Access Compliance Report Public Rights-of-Way (Curb Ramps)

Main Street: PLAZA_WY Cross Street: HOLT_AVE Location: SE

ADA ID: RPRK220121115801 Ramp Type: Type 4 - Parallel Initial Pass/Fail: Fail Overall Compliance: No Severity Score: 2

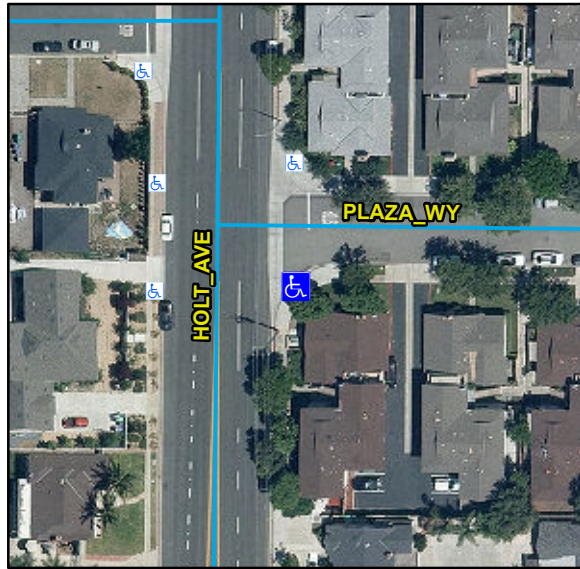
Compliance	Description	Data	Compliance	Description	Data
N/A	Ramp Length LT (in)	105	N/A	Ramp Length RT (in)	88
Yes	Ramp Width LT (in)	91	Yes	Ramp Width RT (in)	91
Yes	Ramp Run Slope LT (%)	5.2	Yes	Ramp Run Slope RT (%)	1.9
No	Ramp Cross Slope LT (%)	2.7	Yes	Ramp Cross Slope RT (%)	1
N/A	Landing Present	N/A	N/A	DWS Provided	N/A
N/A	Landing Length (in)	N/A	N/A	DWS Contrast	N/A
N/A	Landing Width (in)	N/A	N/A	DWS Length (in)	N/A
N/A	Landing Run Slope (%)	N/A	N/A	DWS Full Width	N/A
N/A	Landing Cross Slope (%)	N/A		DWS Offset Type	N/A
N/A	Landing Movement Obstructed?	N/A	N/A	DWS Offset Left (in)	N/A
	Landing Movement Type	N/A	N/A	DWS Offset Right (in)	N/A
N/A	Landing Shared	N/A			
N/A	Clear Space	Yes			
N/A	Clear Space To Crosswalk (in)	N/A			
N/A	Marked Crosswalk 1	No	N/A	Marked Crosswalk 2	No
	Crossing 1 Direction	N		Crossing 2 Direction	W
	Marked Crosswalk 1 Width (in)	N/A		Marked Crosswalk 2 Width (in)	N/A
N/A	Ramp Inside Crosswalk 1	N/A	N/A	Ramp Inside Crosswalk 2	N/A

Remove & Replace Curb Ramp With Two New Directional Ramps or Equivalent.

R304.5.3, STD 1115
